VS1005	
TITLE: vs1005bob_20	
Document Number:	1
Date: 3.9.2018 13.26	REV: 2.0
Sheet: 1/3

ANALOG I/O		
TITLE: vs1005bob_20		
Document Number:	1	REV: 2.0
Date: 3.9.2018 13.26	Sheet: 2/3

VS23S040	
TITLE: vs1005bob_20	
Document Number:	REV: v.2.0
Date: 3.9.2018 13.26	Sheet: 3/3

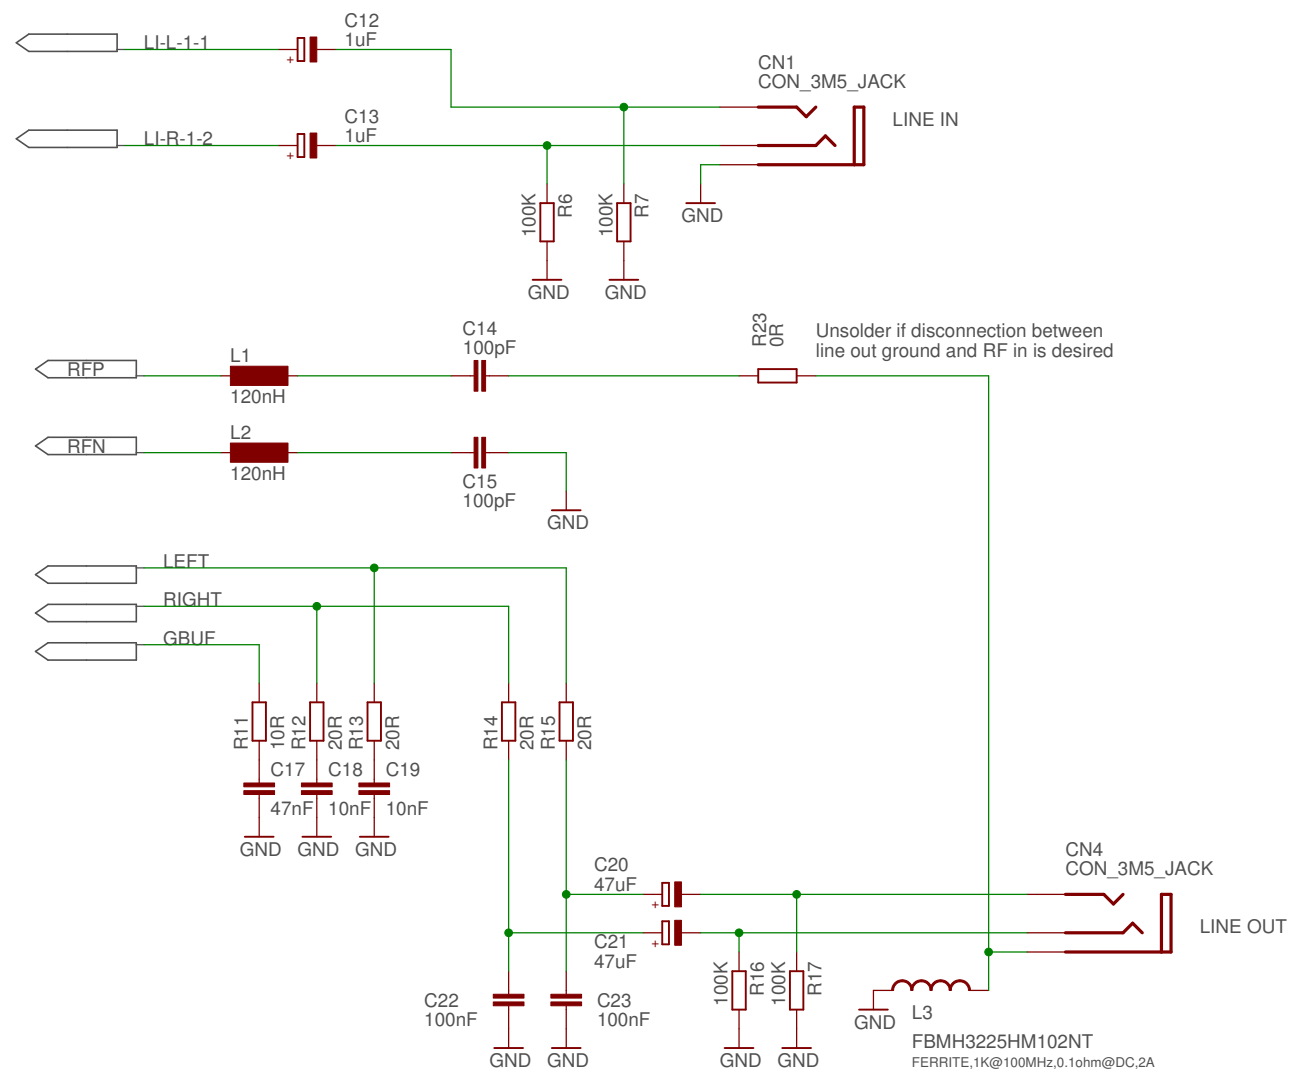
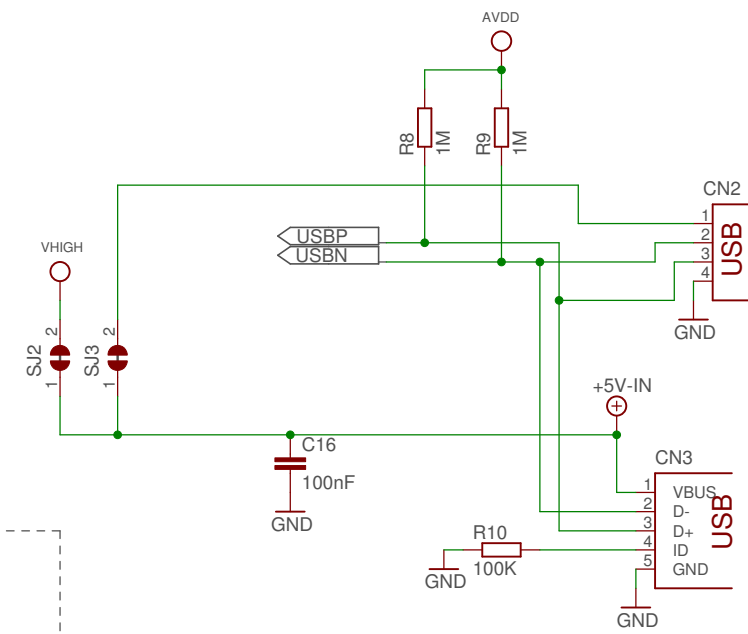
v.1.2
 - capacitor CF1 value changed
 v.1.4
 - silkscreen modified for JP1..4 placement
 v.1.5
 -added RP4 and R21
 -added fiducials to bottom layer
 -note about CP1

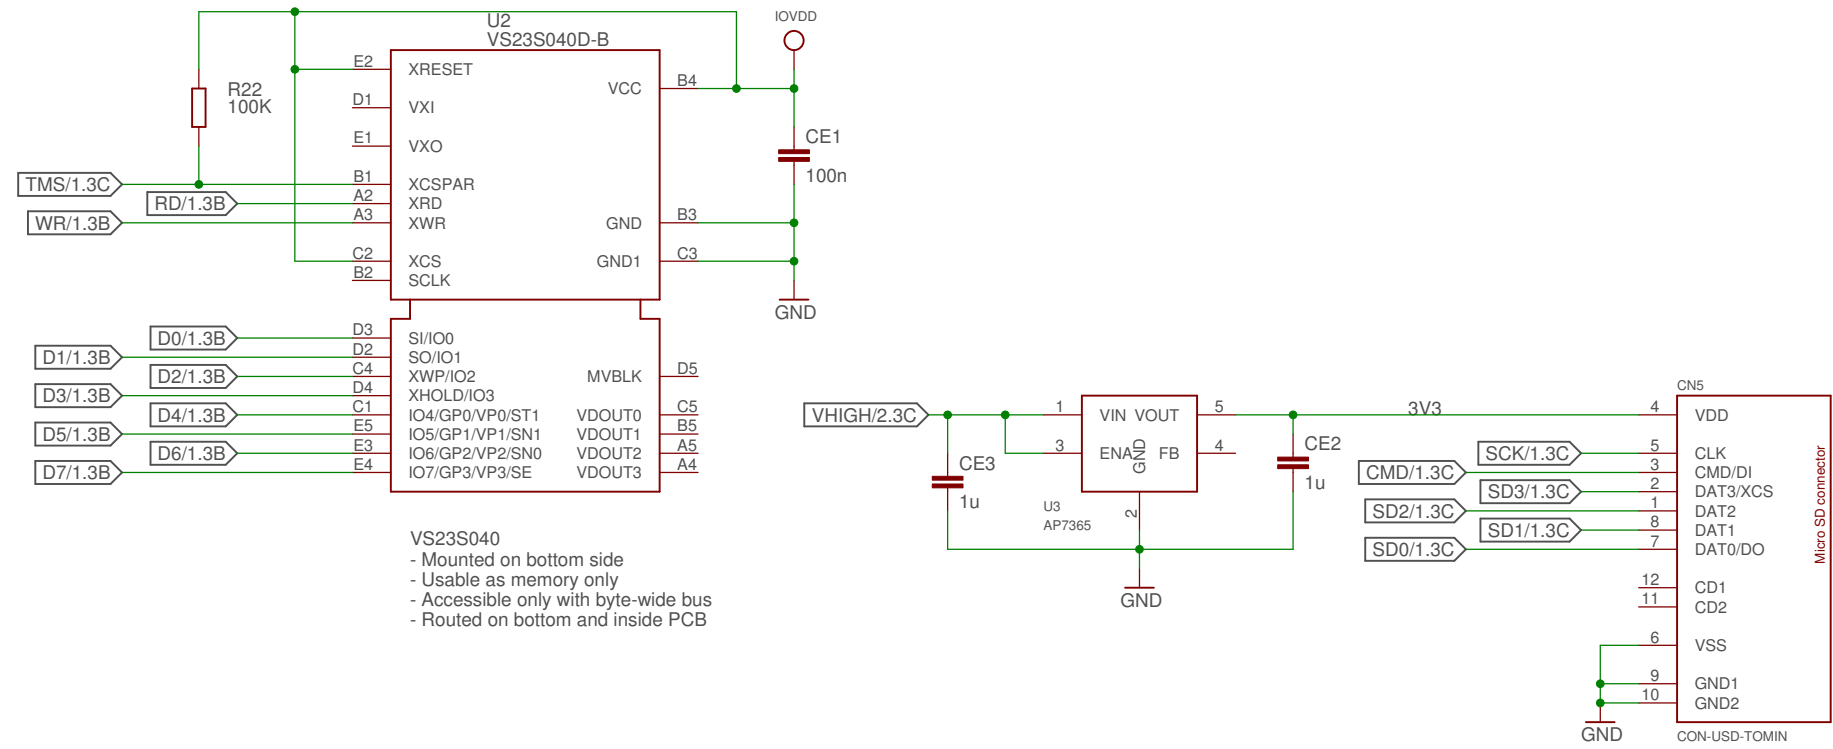
V.1.1
 - RTC crystal changed to SMD type
 - USB wiring optimized
 - GND plane optimized
 - RS232 Markings on silkscreen
